STAFF REPORT

Certificate of Appropriateness Request

Case No.:	21-90200050
Address:	3240 7 th Ave. N.
Legal Description:	KENWOOD SUB ADD BLK 20, LOT 6
Parcel ID No.:	14-31-16-46350-020-0060
Date of Construction:	c. 1925
Local Landmark:	Kenwood Section – Northwest Kenwood Local Historic District (18-90300008)
Owner:	Keystone Executive Capital LLC
Agent:	Eric Decelles
Request:	Review of a Certificate of Appropriateness for the after-the-fact replacement of windows at 3240 7 th Ave. N.

BEFORE Before

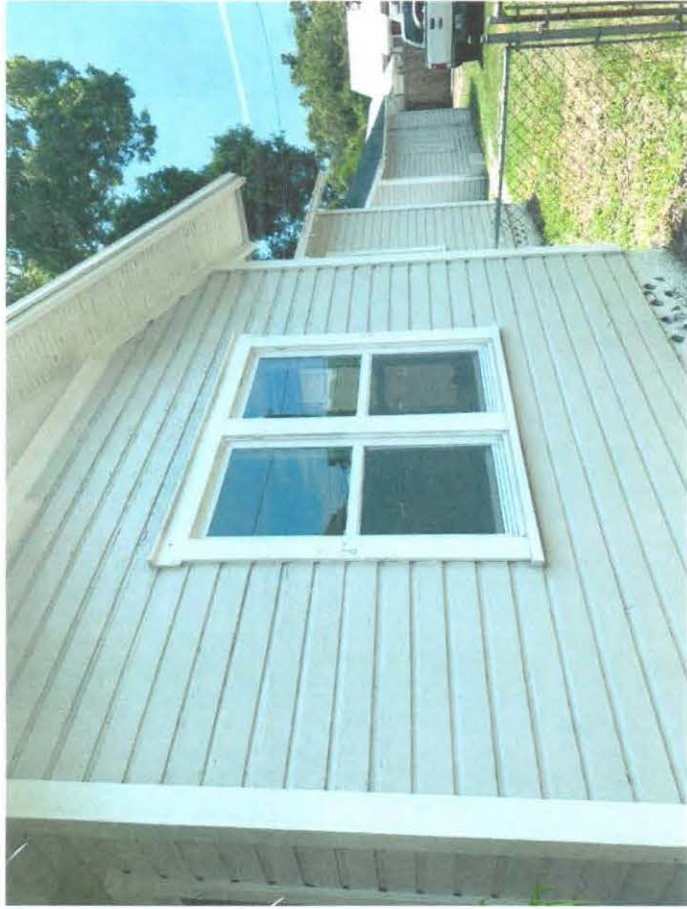
The project removed historic fabric and replaced wood sashes with vinyl. While the windows' size and one-over-one configuration was replicated, the preservation of historic windows is recommended if possible. Staff was unable to closely observe the condition of the original windows before they were replaced.

Inconsistent The window frames are vinyl, which is a visually modern material.

Based on a determination of general consistency with Chapter 16, City Code of Ordinances, staff recommends that the Community Planning and Preservation Commission **approve** the Certificate of Appropriateness request for the replacement of windows at 3240 7th Ave. N., a contributing property to a local historic district of the St. Petersburg Register of Historic Places. The following conditions should be noted:
